Before the FEDERAL COMMUNICATIONS Commission Washington, DC 20554

In the Matter of)	
)	
Globalstar, Inc. Petition for Rulemaking to)	RM No. 11685
Reform the Commission's Regulatory)	
Framework for Terrestrial Use of the Big LEO)	
MSS Band)

COMMENTS OF CLEARWIRE CORPORATION

Figure 2: A 22 MHz Channel Produces Two 22 MHz Shelves

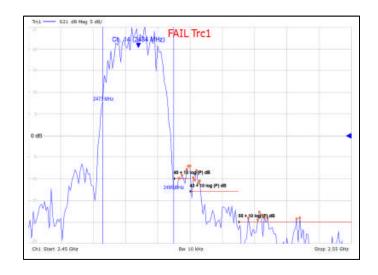
Globalstar's TLPS concept is no exception. As shown in the graphic below, which is reproduced from the Globalstar's petition, deploying a twenty-two megahertz channel will produce two, twenty-two megahertz shelves of elevated OOBE that will affect BRS-EBS licensees in the 2.5 GHz band:⁴³

The first (higher) shelf of elevated OOBE runs from roughly 2495 MHz to 2515 MHz (Globalstar's graphic breaks this shelf into two components), and the second (lower) shelf of

elevated OOBE runs from roughly 2515-2545 MHz. BRS-EBS licensees affected by the higher shelf of OOBE include BRS-1, EBS-A1, EBS-A2, and a portion of EBS-A3. Licensees affected by the lower shelf of OOBE include EBS-B1, EBS-B2, and EBS-B3.
